# UNITED STATES PATENT AND TRADEMARK OFFICE

APPLICATION NO.	FILING DATE	FIRST NAMED INVENTOR	ATTORNEY DOCKET NO.	CONFIRMATION NO.
10/524,408	02/14/2005	Peter Geskes	016906-0374	4673

<b>Office Action Summary</b>	Application No. 10/524,408	Applicant(s) GESKES ET AL.	
	Examiner Leonard R. Leo	Art Unit 3744

### **DETAILED ACTION**

**FIG. 18**

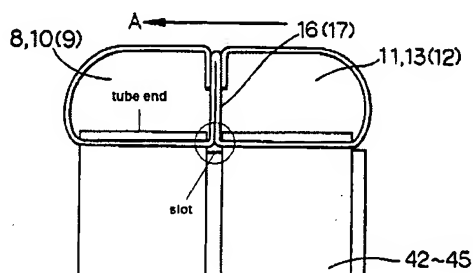
Regarding claims 14 and 23, Kuroyanagi et al discloses a single tube having a slot in the end (Figure 18) to receive longitudinal partition 16.

Regarding applicants' remarks with respect to claim 14, Figure 18 (shown below) of Kuroyanagi et al discloses an end of flat tube 42, 44 (43, 45) having a slot (circled) to accommodate the partition wall 16.
